**FOUR COUNTY SC LIDAR
QUALITY ASSURANCE
ANDERSON COUNTY REVIEW**

UNITED STATES GEOLOGIC SURVEY
AND
SOUTH CAROLINA DEPARTMENT OF NATURAL
RESOURCES

USGS CONTRACT: G10PC00025
TASK ORDER G11PD01086

First review: October 31, 2011
Second review: February 17, 2012

Figure 2: Overall project flightline exhibit (left) and enlarged view (right)

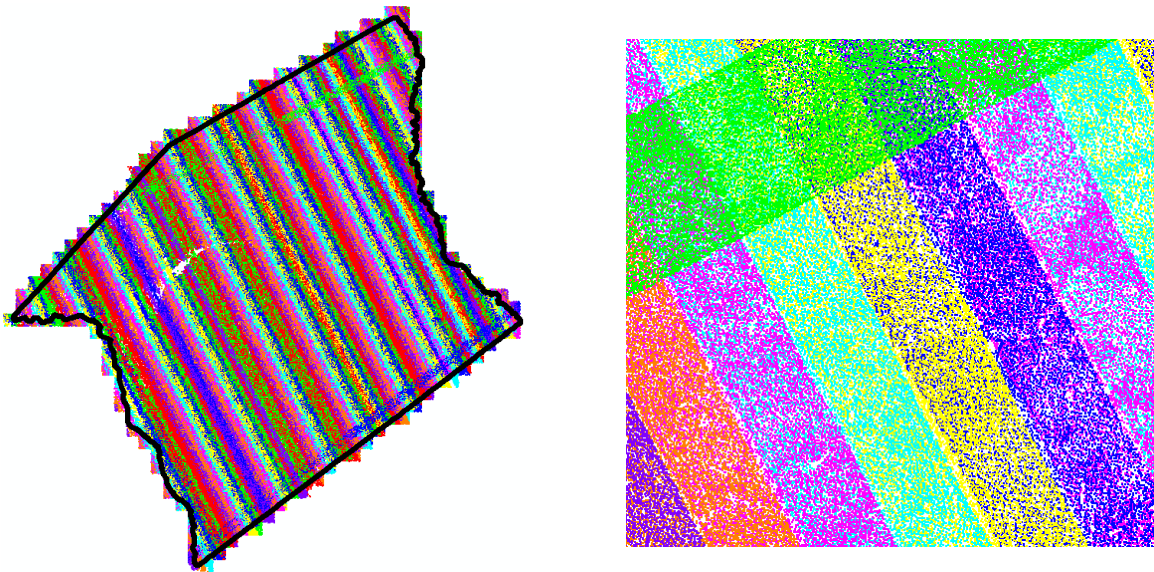
The flightlines were flown with a sidelap of 45 to 50%. The collected data couldn't have holidays and needed to have periodic and local calibration checks. No holidays were noted in the review of 10% of the project area. The exhibits below show the extents of sidelap:

Figure 3: Anderson County Checkpoints

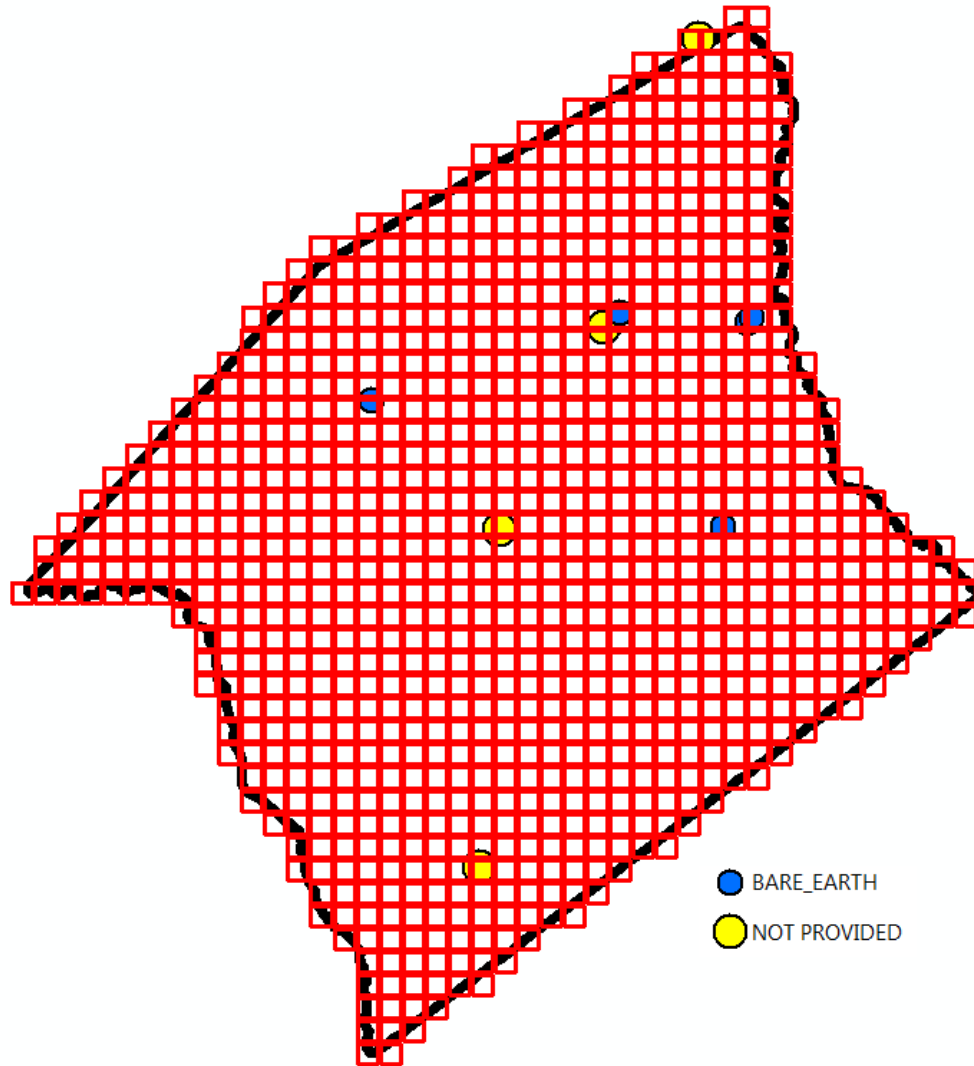
The Criteria also requires GPS baseline lengths to be less than 25 miles. The GPS baseline lengths are established by the distance between check points. Nine check points were collected for the Anderson County data collection – the classification was not provided for four points, and five points are classified as bare earth. The figure below shows the location of said checkpoints in relation to Anderson County and the provided tiles.

Figure 4: Forward vs. Reverse Post-Processed Solution – Lift 072B

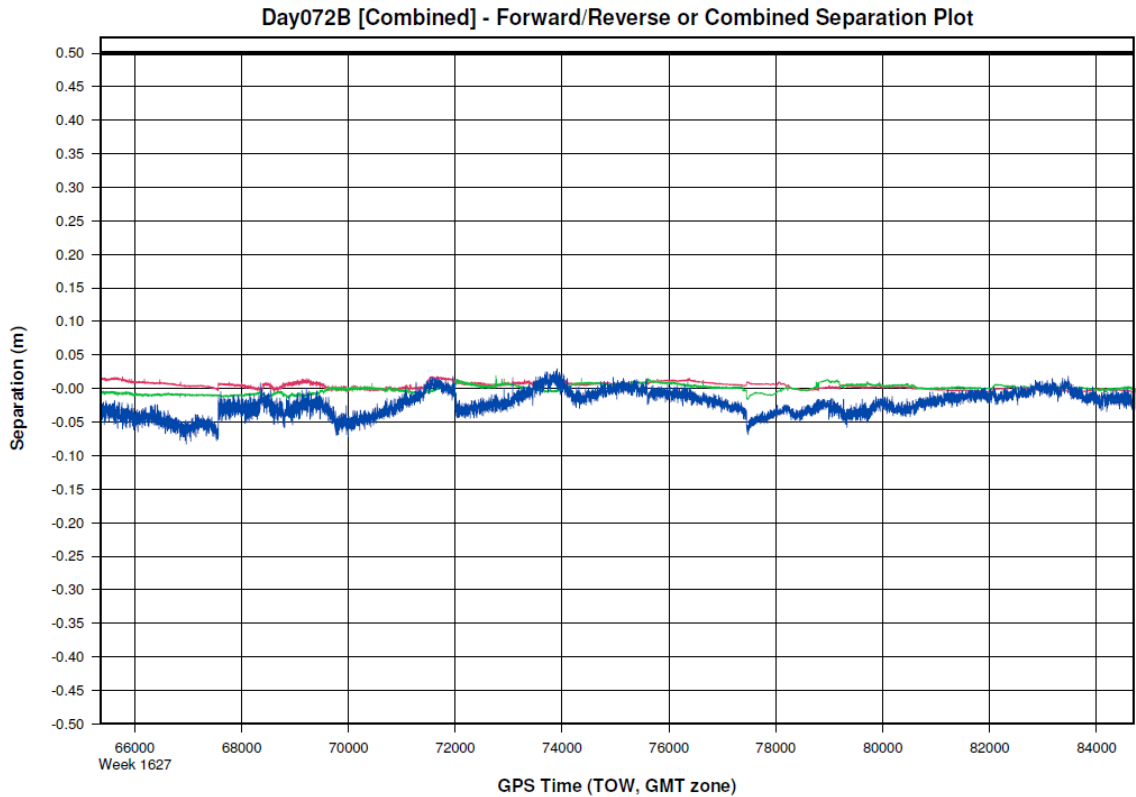
Additionally, the Criteria requires the GPS trajectories to be evaluated with forward and reverse comparisons within 10-20 cm. The GPS solution chart below, as provided by Dewberry, shows forward and reverse comparisons within 3 - 7 cm as provided in the TriCounty_SC_Report.pdf.
